To: INCITS Technical Committee T10
From: Fred Knight, Network Appliance
Email: knight@netapp.com
Date: Nov 20, 2008
Subject: SBC-3 Thin Provisioning Commands

spc4r16 – SCSI Primary Commands – 4
sbc3r15 – SCSI Block Commands – 3
ssc3r04a – SCSI Sequential Commands – 3
08-341r0 – Thin Provisioning Management Commands
T13/e07154r6 – ATA8-ACS2 TRIM proposal (accepted)
T13/e08137 – ATA8-ACS2 DRAT – Deterministic Read After Trim (proposal).

Figure B – Logical Block State Transitions

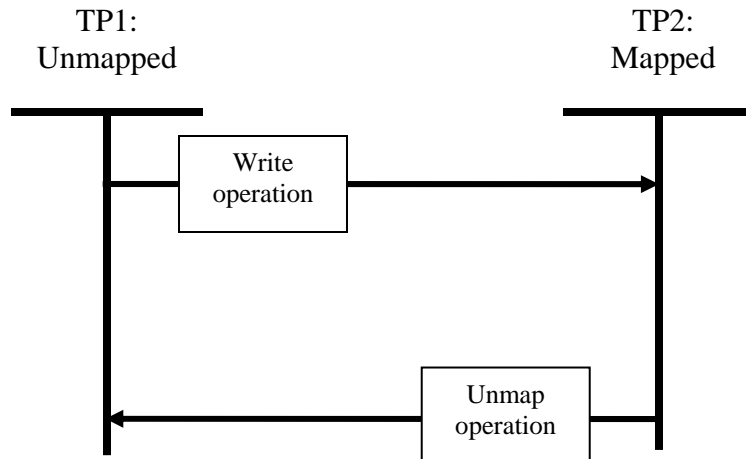
Transitions between the mapped and unmapped state are shown in figure b.

4.4.1.2 TP2: Mapped state

When in the mapped state, a relationship exists between the LBA and a physical block. User data and protection information read without error from a logical block in the mapped state shall be the user data and protection information that was most recently written to that LBA. If data has not been written to that LBA, user data and protection information read from the LBA shall be the user data and protection information that was established during initialization (see 4.7).

4.4.1.2.1 Transition TP2:Mapped state to TP1:Unmapped state

This transition occurs when an unmap operation completes without error (see 4.4.1.5.2). As a result of this transition, the user data retrieved by the next read operation or verify operation is indeterminate.

4.4.1.3 TP1: Unmapped state

When in the unmapped state, no relationship is defined between the LBA and a physical block (see figure A). For an LBA in the unmapped state, user data and protection information retrieved during a read operation or verify operation:

4.4.1.3.1 Transition TP1:Unmapped state to TP2:Mapped state

This transition:

- a) shall occur when a write operation occurs. As part of processing a write operation, the device server may cause LBAs other than those specified by that write operation to transition from unmapped state to mapped state; or
- b) may occur at any other time for vendor specific reasons.
